Access Compliance Report

Public Rights-of-Way

Intersection ID: 2765	Main Street: BEAUVISTA_DR	Cross Street: HICKORY_COVE_LN	Location: SW
ADA ID: 31F7110EF1D9	Ramp Type: PerpDiag	Initial Pass/Fail: Fail	Overall Compliance: No
Severity Score: 21.25			
Codes/Mitigation Info/Possible Solution		Field Measurements/Component Compliance

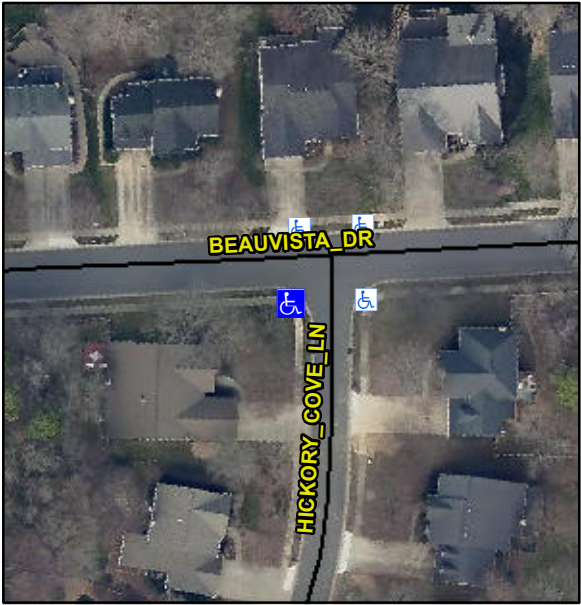
Possible Solutions:						
	Remove & Replace Curb Ramp With Two New Directional Ramps or Equivalent.						
	Surveyor Notes:						
	N/A						
	PROW/ADA:						
	Not Found, R304.5.1, R304.5.3						
Street 1 Name	HICKORY COVE LN	Compliance	Description	Data	Compliance	Description	Data
Stop Condition-Street 2	StopSign	N/A	Ramp Length (in)	49.0	Yes	Ramp Slope (%)	5.9
Street 2 Name	BEAUVISTA DR	No	Ramp Width (in)	39.0	No	Ramp XSlope (%)	6.8
Stop Condition-Street 1	None	N/A	Flare Type LT	N/A	N/A	Flare Type RT	N/A
		N/A	Flare Slope LT (%)	N/A	N/A	Flare Slope RT (%)	N/A
		N/A	Flare Traversable LT?	N/A	N/A	Flare Traversable RT?	N/A
		N/A	Landing Length (in)	N/A	N/A	DWS Provided?	N/A
		N/A	Landing Width (in)	N/A	N/A	DWS Contrast?	N/A
		N/A	Landing Slope (%)	N/A	N/A	DWS Length (in)	N/A
		N/A	Landing X Slope (%)	N/A	N/A	DWS Full Width?	N/A
		N/A	Landing Curb? (Y/N)	N/A	N/A	DWS Offset (in)	N/A
		N/A	Shared Landing?	N/A
